March 20, 2015

**Re: EA1314-01 Jay Project, Dominion Diamond Corporation Developer's Assessment Report – Responses to Information Requests**

Dominion Diamond is pleased to provide you with a first batch of responses to the Information Requests (IRs) received following the submission of the Jay Project Developer's Assessment Report and the responses to the adequacy review.

**Figure 33-1 Counts Lake (D3) Measured vs Modelled Discharge**

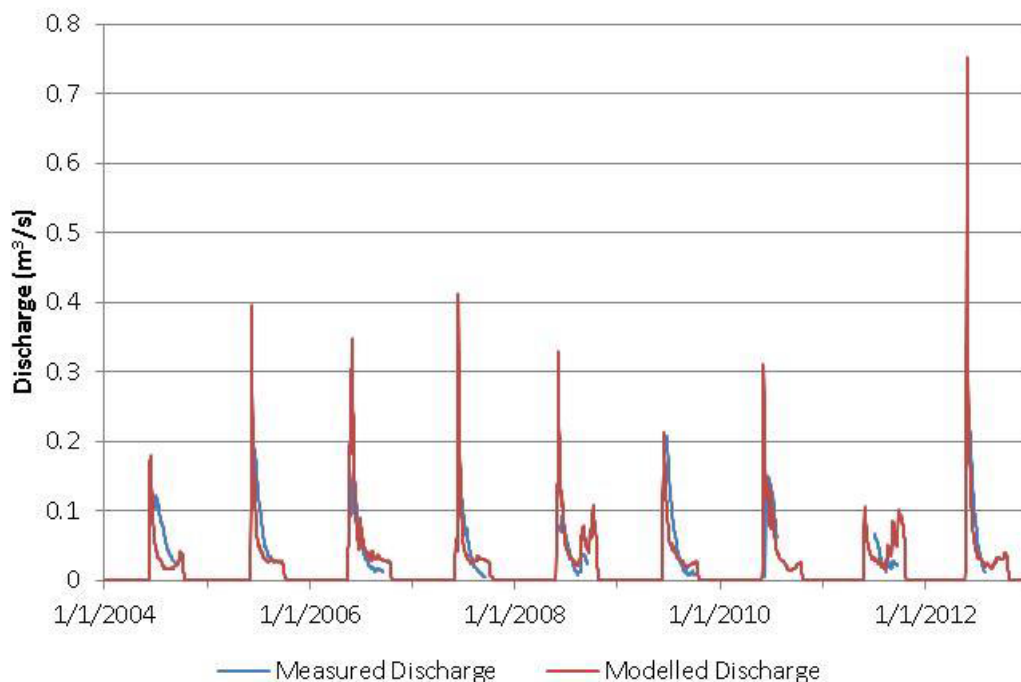
The potential implications of not including the time effects in channels would be to underestimate the time required for flows to be routed downstream in each basin. This has not been observed in the comparison of observed hydrographs to modelled hydrographs.

The timing of flows from the contributing watersheds match measured data as presented in the Developer's Assessment Report, Annex X, Section F3.1.2.3 and Section 8D3.1.5. An example of this is shown in Figure 33-1.

**Figure 35-1 Winter Road Operating Days (2000 – 2013)**

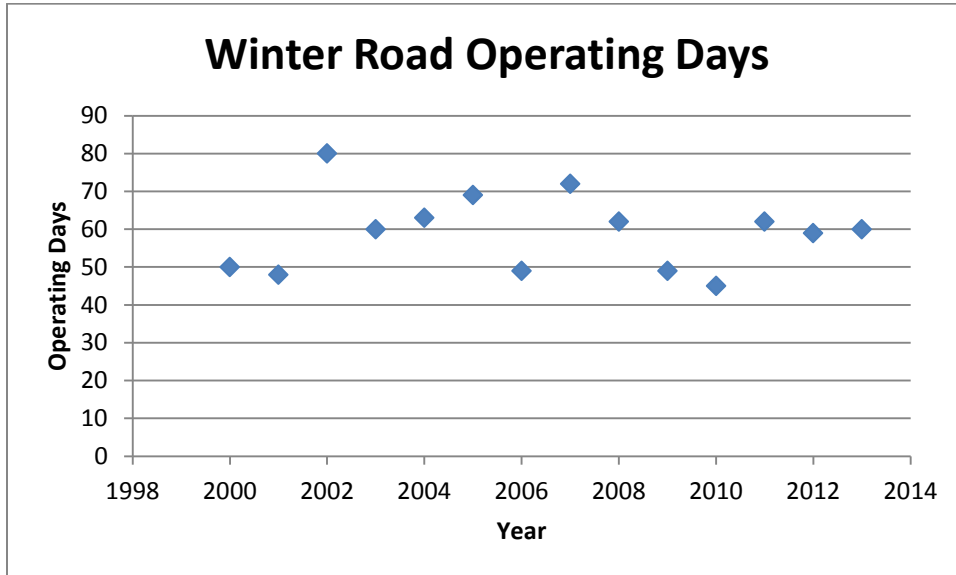
The dataset used to generate Figure 16.3-2 and resultant conclusions is based on the period 1994-2006. As the data is used to determine future effects and related mitigation, the latest data should be used to confirm or amend projections.

As described in Section 16.3 of the Developer's Assessment Report (DAR), a study was conducted by EBA Engineering Consultants Ltd. (EBA 2007) to examine the risks from climate warming on future operations of the Tibbitt to Contwoyto Winter Road by developing a correlation between length of operating season and the cumulative air freezing index for the season (McGregor et al. 2008). Figure 16.3-1 and Figure 16.3-2 presented in Section 16.3 of the DAR are sourced from the McGregor et.al. (2008) report, and therefore, only present information up until 2006. The report found that the combination of winter freezing index and snow cover controls the rate of natural ice growth and the ability of the ice sheet to sustain loads late in the season.

However, conclusions presented in Section 16.3 of the DAR have also included the analysis of annual air temperature data from 1959 to 2013 which indicated a positive statistically significant trend (Section 10.3.1 of the DAR). Annual air temperatures have increased at an estimated rate of 0.05 degrees Celsius per year. The data indicates that the current operational winter road season consists of approximately 65 days. Figure 35-1 graphically shows the number of days the winter road has operated between 2000 and 2013. However, projected changes to the winter freezing index suggests that the operational days may decrease approximately to 54 days by 2020 or beyond. As such, the conclusions within Section 16.3 of the DAR remain appropriate.

Figure 51-1 Jay Project – Conceptual Reclamation Schedule

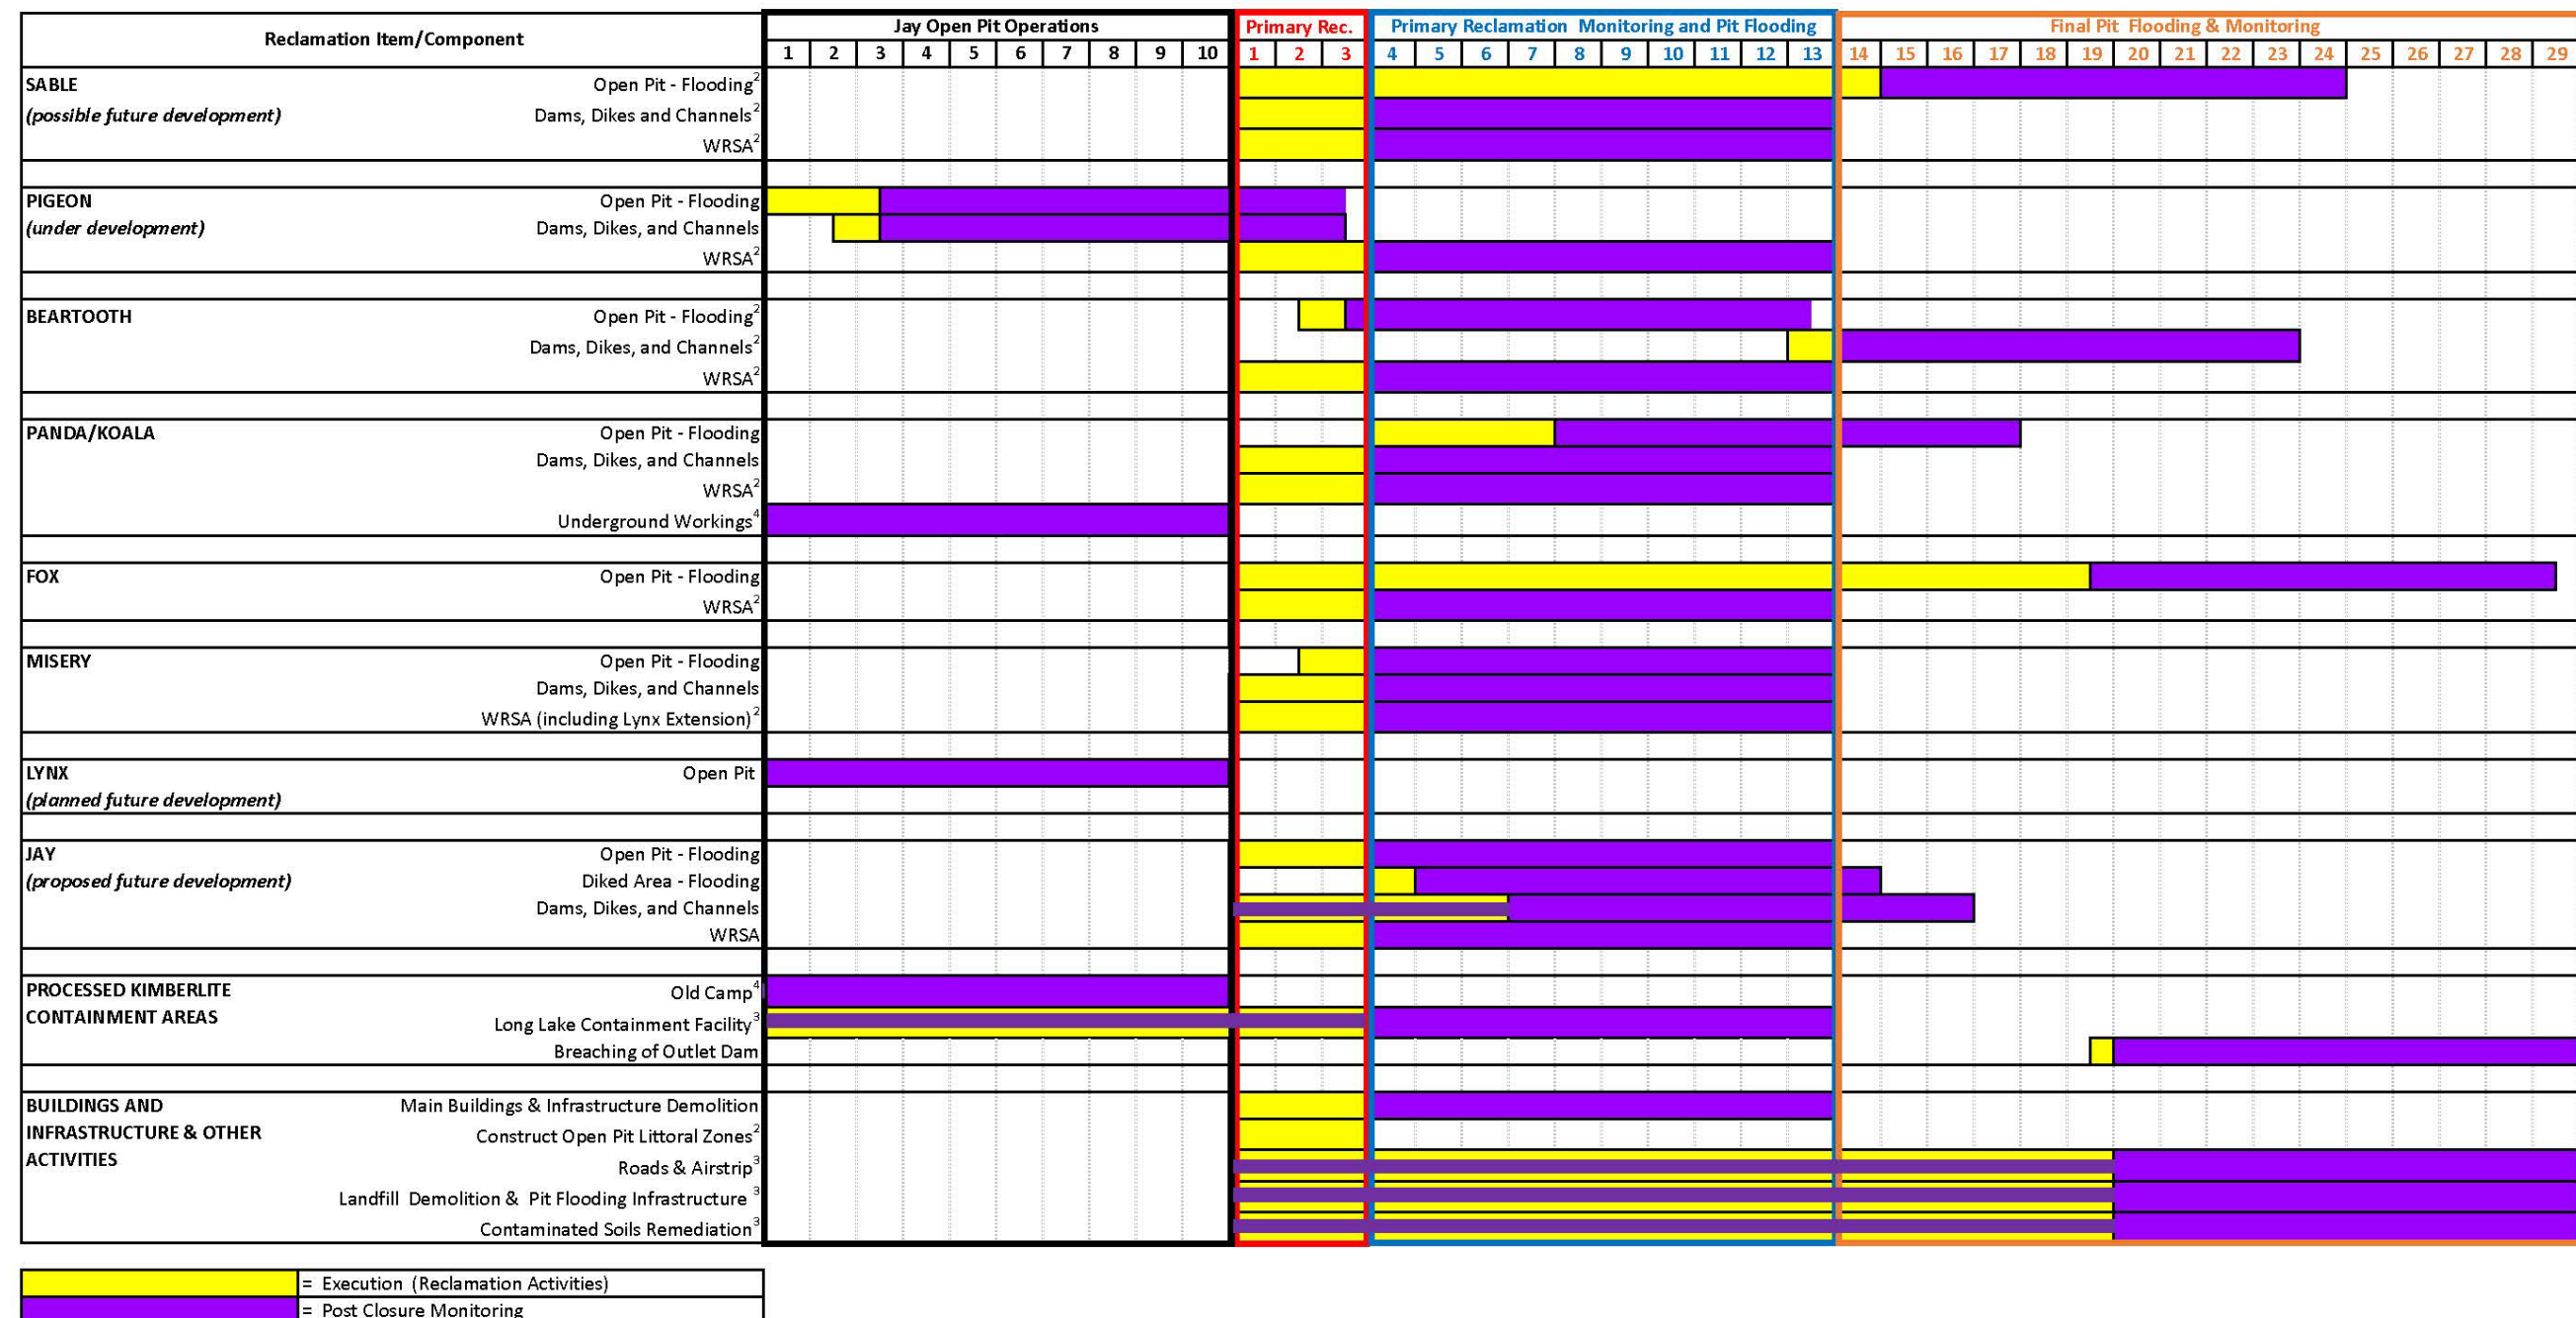
A more detailed schedule that includes actual year of work would be helpful in understanding how progressive reclamation will be carried out across the Ekati Mine. DDEC provides a reclamation schedule for the Jay Project that contains very few details, unlike the schedule that appears in the approved ICRP as Figure 8.5-1.

DDEC should provide a reclamation schedule for the Jay Project that shows the same level of detail and integration with the ICRP Reclamation Schedule (Figure 8.5-1).

A schedule addressing the request above is included as Figure 51-1.

**Figure 52-1 Effects on Lake Ac35 Outlet Discharges – Project Infrastructure and Dike Construction (DAR Figure 8.5-8)**

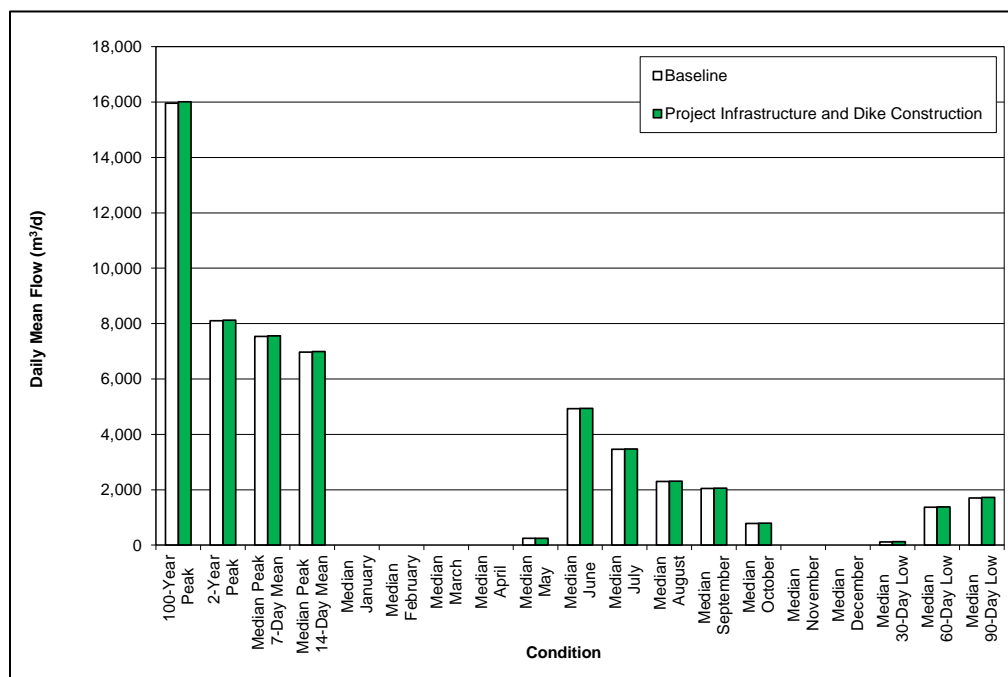
The numbers presented in Figure 8.5-8 do not appear to match the values reported in Table 8D5-47. The values for the 1 in 100 yr peak event indicate a 5.5% increase in the peak flow rate from Lac Ac35.

Please confirm the values in Figure 8.5-8.

The values used to create Developer's Assessment Report (DAR) Figure 8.5-8 - *Effects on Lake Ac35 Outlet Discharges – Project Infrastructure and Dike Construction* (reproduced below as Figure 52-1) are from DAR Table 8D5-47 - *Derived Representative Discharges at Lake Ac35 Outlet – Construction* (also reproduced below as Table 52-1) (Appendix 8D of the DAR). These are shown below as reported in the Jay Project DAR without modification.

**Figure 22-1 Insect Harassment Indices Defined as Potential Harassment Days and Estimates ( $\pm$  SD) of Total Female Bathurst Caribou**

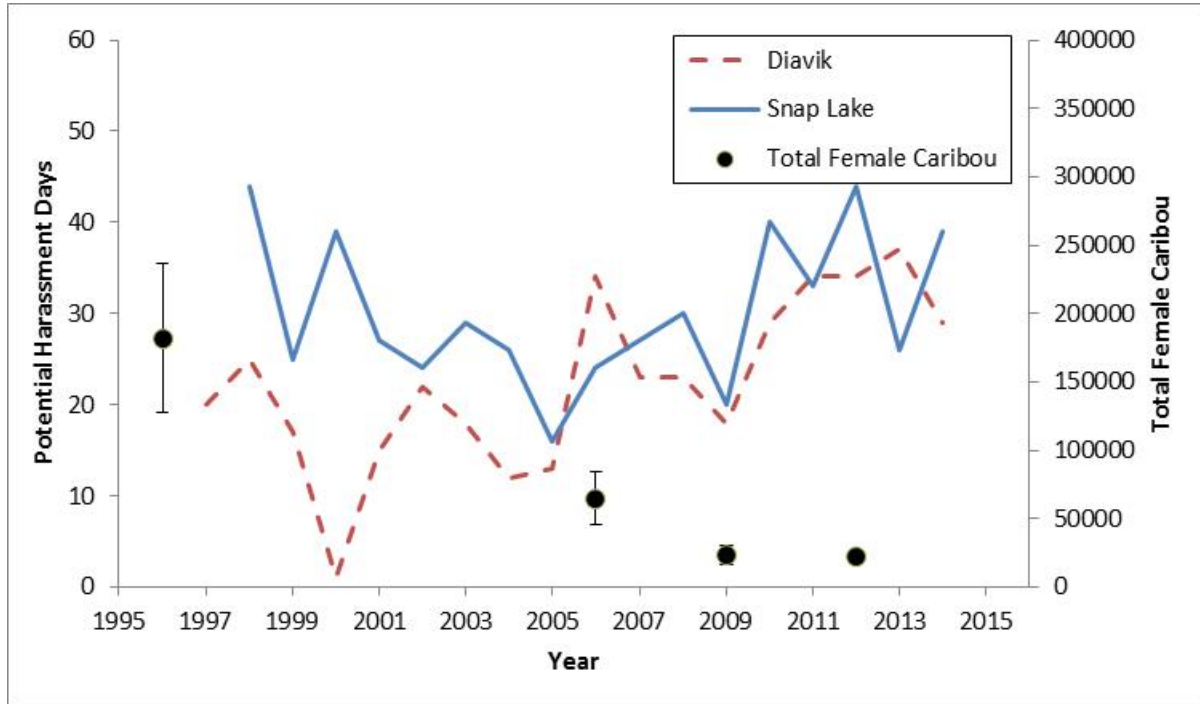
DAR Section(s): 12.4.2.3.1 (Figure 12.4-6)

The graph [Figure 12.4-6] includes meteorological data from Diavik Diamond Mine and Snap Lake Mine, duration of 1993-2013.

Section 12 of the DAR does not contain a Figure 12.4-6. The North Slave Métis Alliance clarified that the intended figure for this request was Figure 12.4-2 of the DAR. To meet this request, a secondary vertical axis was added in order to display the Bathurst population data on the total number of female caribou results shown in Figure 12.2-1 of the DAR (Figure 22-1). Bathurst population data on total female caribou were reported in the DAR, and therefore readily available to meet this request. The trend in total female caribou is consistent with the trend reported for the entire Bathurst herd (Adamczewski et al. 2009).
